ON PRINCIPAL FRONT OF PORTLANI	
Please Read Application And Notes, If Any, Attached	PERMIT	Permit Number: 090705
This is to certify thatStephen J. Blatt/self		FEATI (SSUID)
has permission to Change of Use; From two units AT _5 South St	Î	E027001 111 2 5 2000
provided that the person or persons, fi of the provisions of the Statutes of Ma the construction, maintenance and use this department.	e and of the compaces of	his permit shall comply with all the City of (Portland regulating and of the application on file in
Apply to Public Works for street line give and grade if nature of work requires such information. Not give before the properties of the p	nation of ispection must be and written permission procured this but and or promise in or other section. 2 NOTICE IS REQUIRED.	A certificate of occupancy must be procured by owner before this building or part thereof is occupied.
OTHER REQUIRED APPROVALS Fire Dept. (1477. 2) Author Health Dept		grino Bruke 7/28/05

MEMORANDUM

RE: 5 South Street

LIFE SAFETY DIAGRAMS **5 SOUTH STREET**

ASK-01

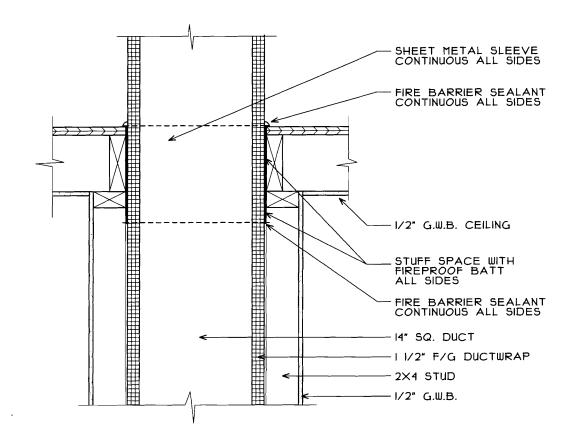
7/15/2009-jmb: Left msg with admn. For Stephen B. To call for details on code items, firestop of new duct, clearances to duct of surrounding walls, new exterior stair details, F/C assembly of furnace room and door type, floor joist bearing(center wall or clear?, new exposed cathedral has 2 beams, not 3, any collar ties?, what the attic space is for, is there a loft.

7/24/2009-jmb: Received revisions from Steve B., question on the height of the exterior stair wall. He is showing 40", needs 42". Tried calling Steve, no answer and cannot leave a message

7/28/2009-jmb: Spoke to Steve B., he will build the wall at stairs to min. 42", I noted this ont he plan, ok to issue

- ASK-01 provides details on the new stairway to grade.
- ASK-02 illustrates typical firestopping at each floor through which the major HVAC duct penetrates;
- ASK-03 indicates those areas in context through a section of the building.
